SK[®] 48-RE

2003-2008 Diesel & V10

Corrected Hole Drilling

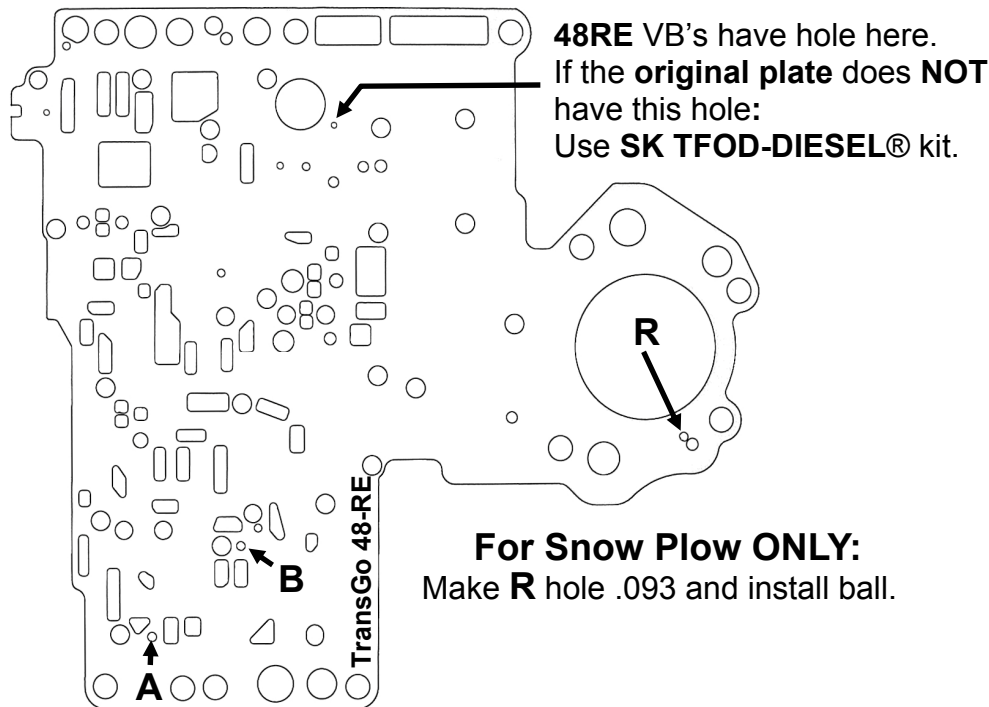
48RE VB's have hole here.
If the **original plate** does **NOT**
have this hole:
Use **SK TFOD-DIESEL[®]** kit.

For Snow Plow ONLY:
Make **R** hole .093 and install ball.

Enlarge holes A & B
with .106 drill. Re-Install
original check balls.

Use this for correct hole locations.
A limited number of kits were released with
hole "B" arrow pointing slightly up and to the
right of its normal location.
We apologize for the error and any
inconvenience this may have caused.
